PLANNING COMMISSION - REGULAR MEETING

PC Meeting Date: January 20, 2026
Agenda Title: Schoolhouse Commons Rezoning
Zoning District: B-1 Town Center
Requested Action: Public Hearing for Planning Commission
Staff Lead: Lydia Schauss, Town Planner
Emily Kyriazi, Town Manager and Zoning Administrator

The applicant has submitted a rezoning application for the Schoolhouse Commons property, requesting a change from the existing B-1 Town Center zoning designation to a split zoned configuration consisting of B-1 Town Center and R-2 Residential.

<p align="center">VIRGINIA DEPARTMENT OF TRANSPORTATION PRINCE WILLIAM LAND USE PROJECT REVIEW COMMENT AND RESOLUTION SHEET</p>				<p>TIA: REVIEW COMPLETE</p>		<p>COMMENT CATEGORIES: 1. REQUIREMENT 2. RECOMMENDATION 3. CLARIFICATION</p>	
<p>COUNTY PROJECT NUMBER: REZ 2025-001</p>			<p>DEVELOPER/ENGINEER: THE KDL GROUP LLC</p>		<p>REVIEWER(S): RORY HARTSOE RORY.HARTSOE@VDOT.VIRGINIA.GOV</p>		<p>DATE: 11/24/25; 1/7/26</p>
<p>PROJECT NAME: SCHOOLHOUSE COMMONS</p>			<p>REVIEW PHASE & TYPE: 2ND REVIEW, REZONING</p>		<p>DISCIPLINE: PWC LAND USE</p>

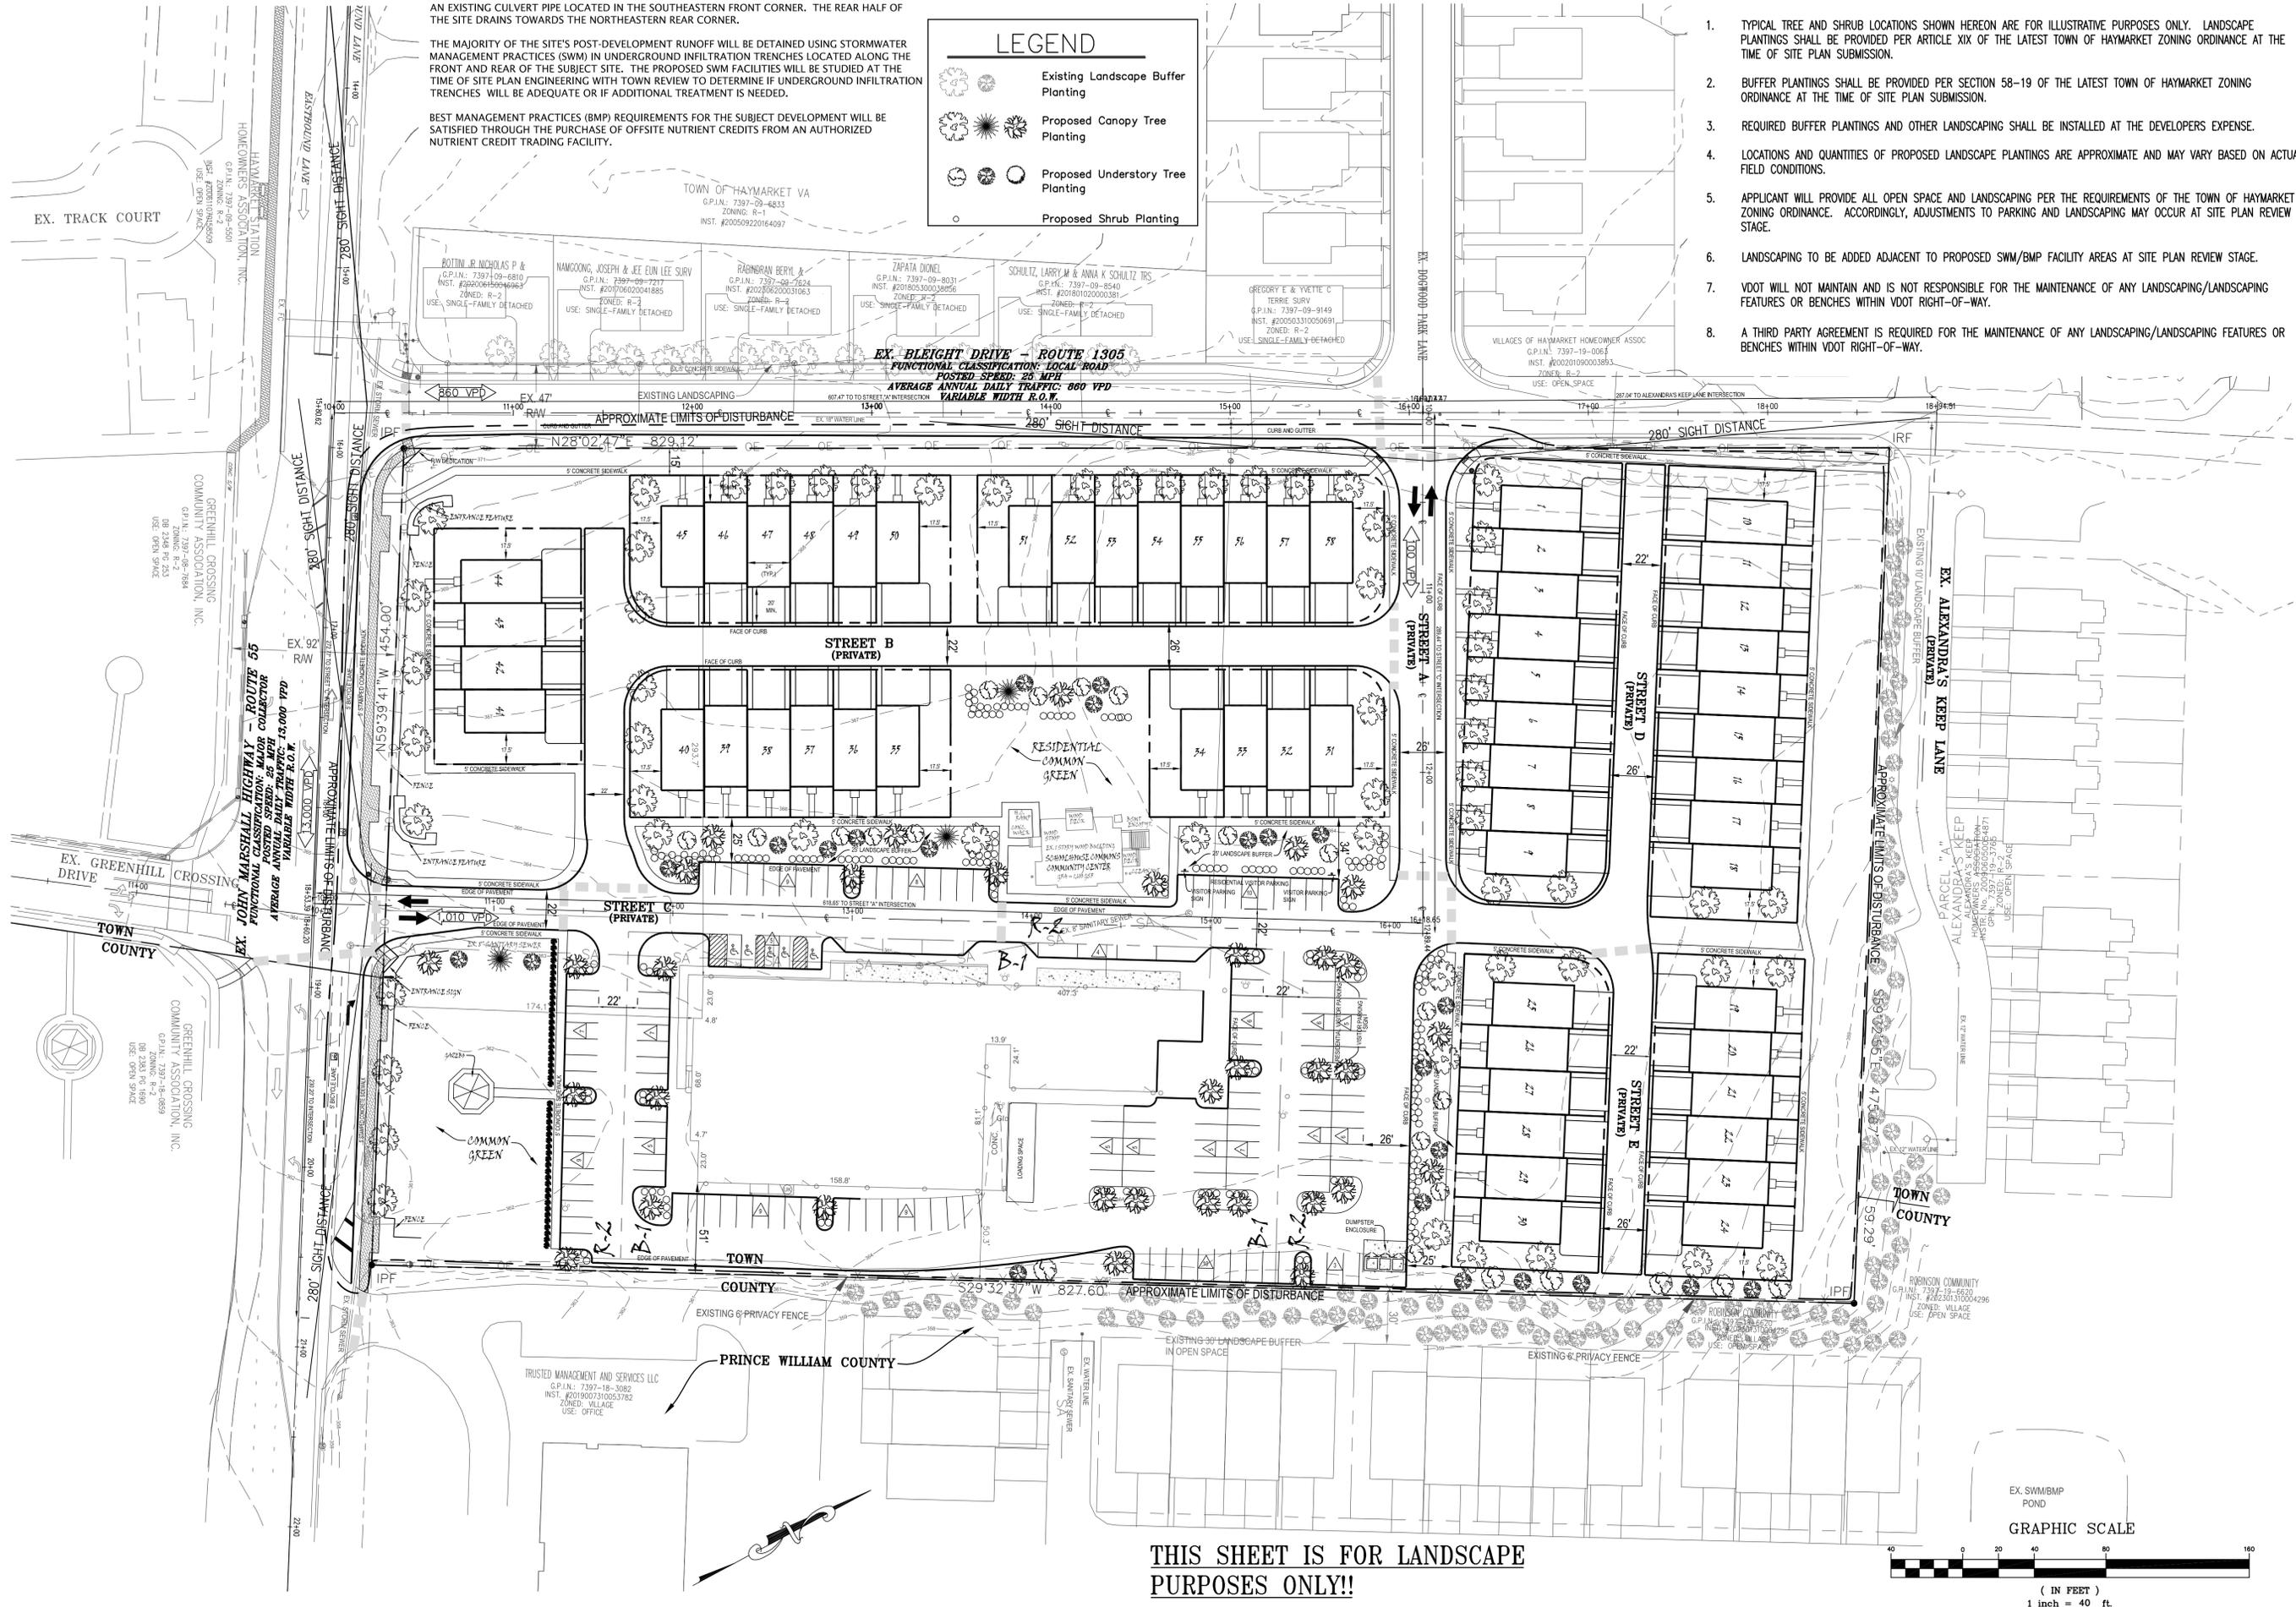
ITEM NO.	DWG. No. ⁽¹⁾	COMMENTS	COMMENT CATEGORY	RESPONSE ⁽²⁾	DATE: 02-26-26	FINAL DISPOSITION ⁽³⁾	
2.18	9	Move all landscaping outside of VDOT ROW. 1/7/26: Please provide a note that VDOT will not maintain and is not responsible for the maintenance of any landscaping/landscaping features or benches within VDOT ROW. Additionally, provide a note on who is responsible for maintaining it. Note that if it is the HOA, then a 3 rd party maintenance agreement will be needed.	1	Notes 7 and 8 have been added on sheet 9.

2.19	9	Please include sight distance lines on this sheet to verify that the landscaping is not hindering sight.	1	Sight distance lines have been provided on sheet 9.

2.20	9	Demonstrate that the requirements of Figure B(1)-20 of Appendix B(1) are being met.	1	The typical landscape plantings have been located outside of the proposed sight distance lines. Additionally, please refer to Note #1 on sheet 9.

TYPICAL SECTION, WASHINGTON STREET - ROUTE 55 FRONTAGE IMPROVEMENTS (WEST OF STREET "C" ENTRANCE)
(NOT TO SCALE)

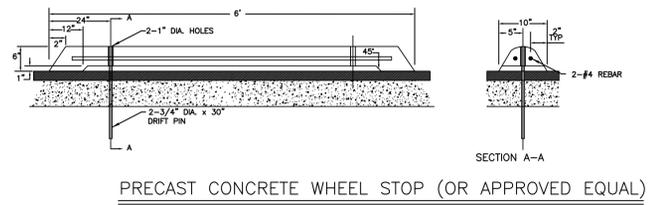
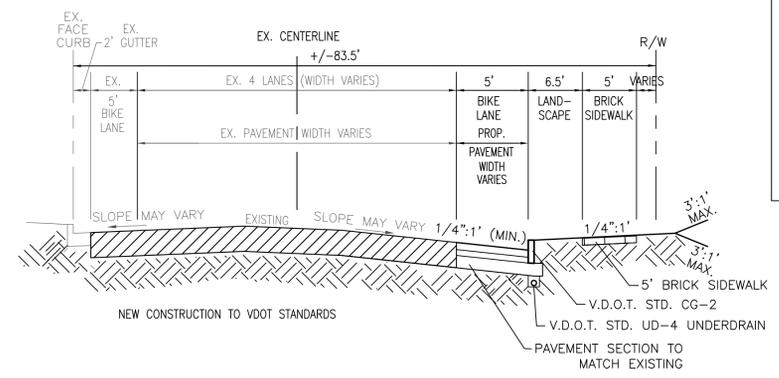
2.23	10	Update the typical sections for Washington Street to utilize standard CG-2 not modified.		The Washington Street Typical Sections have been revised on sheet 10.

TYPICAL SECTION, WASHINGTON STREET - ROUTE 55 FRONTAGE IMPROVEMENTS (EAST OF STREET "C" ENTRANCE)
(NOT TO SCALE)

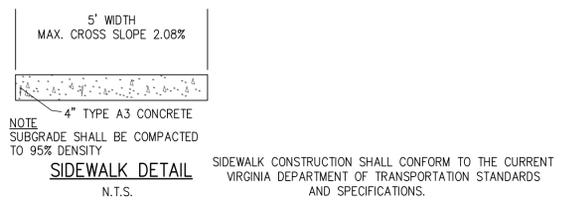
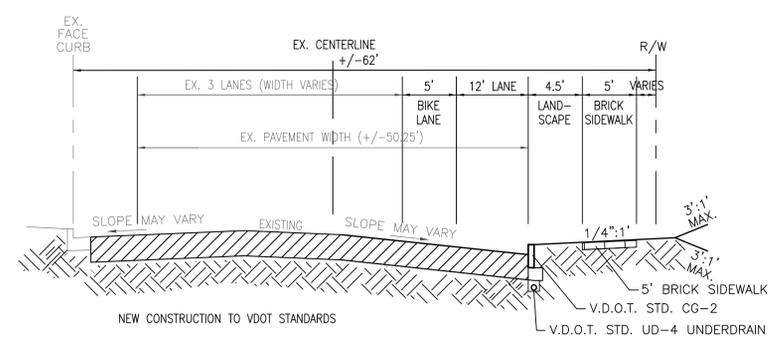
ITEM NO.	DWG. No. ⁽¹⁾	COMMENTS	COMMENT CATEGORY	RESPONSE ⁽²⁾	DATE: 02-26-26	FINAL DISPOSITION ⁽³⁾	
2.22	10	Provide a typical section for Washington St east of Greenhill Crossing. 1/7/26: Per VDOT's Road Design Manual Appendix A(1), the minimum sidewalk buffer width is 4.0'. Please increase the 3.5' Landscape to at least 4.0' from back of the curb to the sidewalk. Additionally, include the width of the existing pavement section and a min of 1.0' shy line from the travel lane to the CG-2.	1	The Typical Section for Washington Street east of Ex. Greenhill Crossing Dr. has been revised on sheet 10.

TYPICAL SECTION EX. BLEIGHT DRIVE ROADWAY IMPROVEMENTS
(NOT TO SCALE)

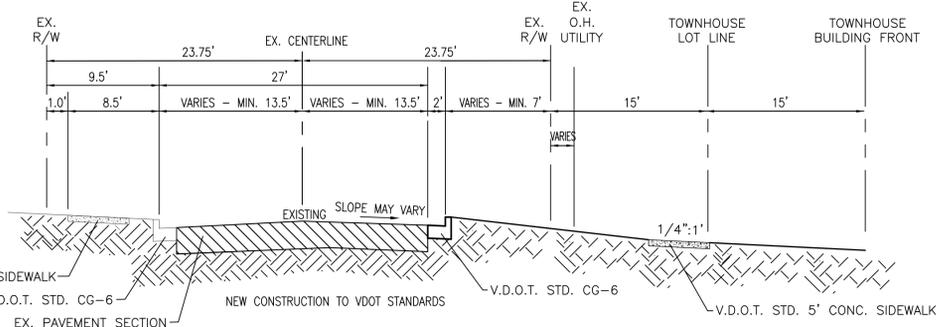
2.21	10	For the typical section Ex. Bleight Dr, correct the 2' label on the VDOT CG-6 to go to the face of curb, not the back of curb.	1	The Ex. Bleight Dr. typical section has been revised on sheet 10.		Comment closed 1/7/26.
